Work Order ID 124220

D3394-041/-043 LUG ASSEMBLY

DRAWING NO. D3394	TITLE LUG	REV. B	DART AEROSPACE LTD ENGINEERING ORDER		D.E.O. NO. D3394-B-1	SHEET NO. SHEET 1 OF 1	SCALE NTS
DRAWN AJS	CHECKED	MFG. APPR.	APPROVED	DE APPR.			
DATE 09.11.04	DATE 09.11.04	DATE 09.11.04	DATE 09/11/04	DATE 09/11/04

DRAWING NO. D3394	TITLE LUG	REV. B	DART AEROSPACE USA, INC ENGINEERING ORDER		D.E.O. NO. D3394-B-2	SHEET NO. SHEET 1 OF 1	SCALE NTS
DRAWN <i>GP</i>	CHECKED <i>SC</i>	MFG. APPR. <i>M</i>	APPROVED <i>MP</i>		DE APPR. <i>MP</i>		
DATE 11.05.02	DATE 11.05.09	DATE 11.05.08	DATE 11.05.08		DATE 11.05.09

SHEET 4 ZONE A,1 MODIFY SECTION A-A AS SHOWN:

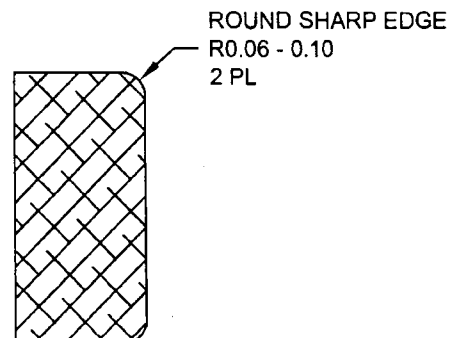
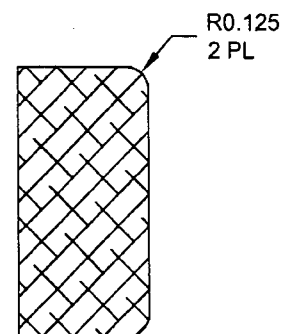
REASON: DRAFTING ERROR

IS:

WAS:

D3394-1RG LUG (SHOWN)
D3394-3RG/-5RG LUGS (SIMILAR)
D3394-041RG/-043RG/-045RG LUG ASSEMBLIES (SIMILAR)

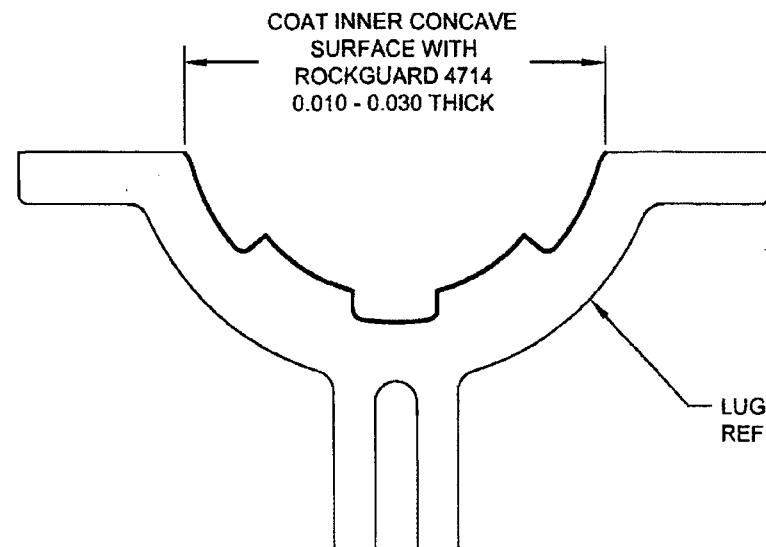
ADD D3394-xRG OPTION

D3394-xRG MOUNTING LUGS ARE INDENTICAL TO D3394-x MOUNTING LUGS, HOWEVER AFTER FINISH, COAT INNER CONCAVE SURFACE WITH "PLUS ONE ROCKGUARD 4714" AS SHOWN BELOW.
